January 7, 1941

FUEL LINE CHANGE

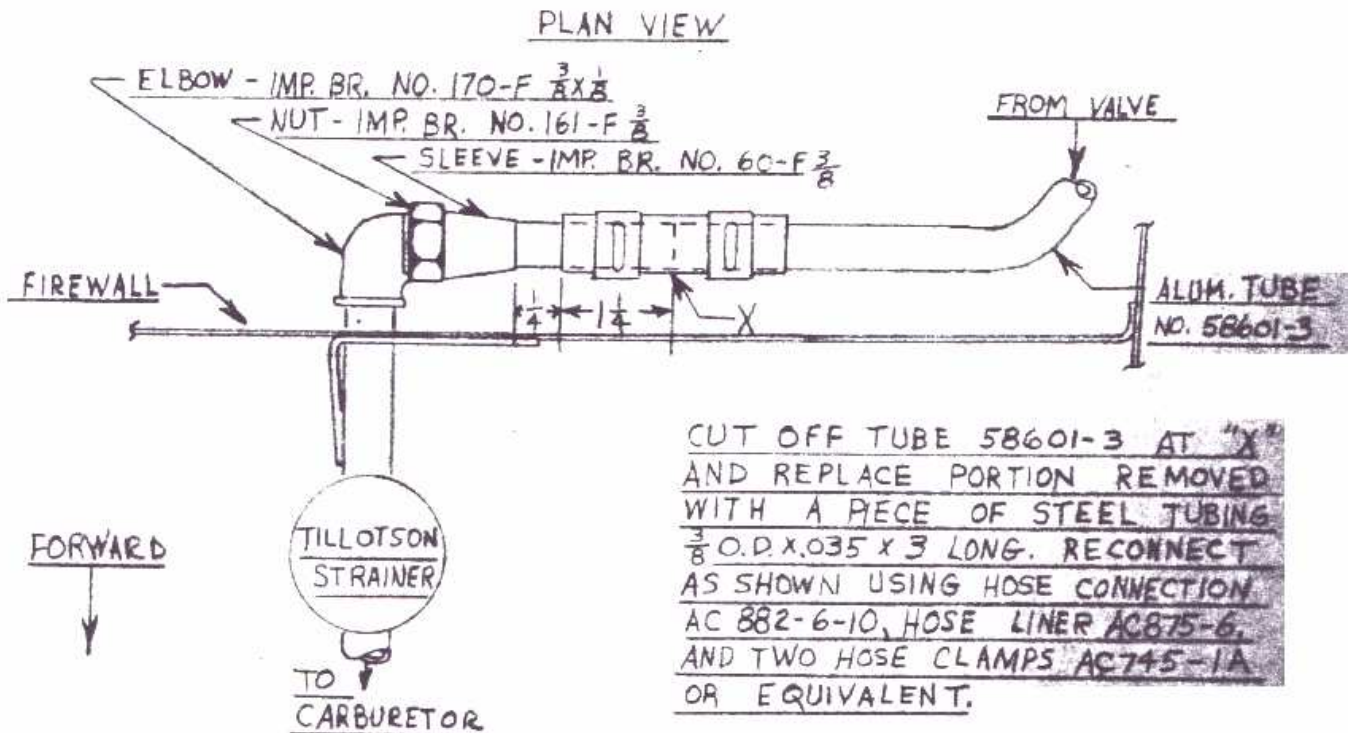
Fuel line failures have occurred just aft of the firewall, which have led us to make a change at our factory, and to recommend that you make the same change on any and all subject aircraft in your possession immediately. The Civil Aeronautics Administration will require that our recommendation be complied with prior to annual relicensing, and that pertinent notations have been made in the log book. We illustrate the change by sketch below.
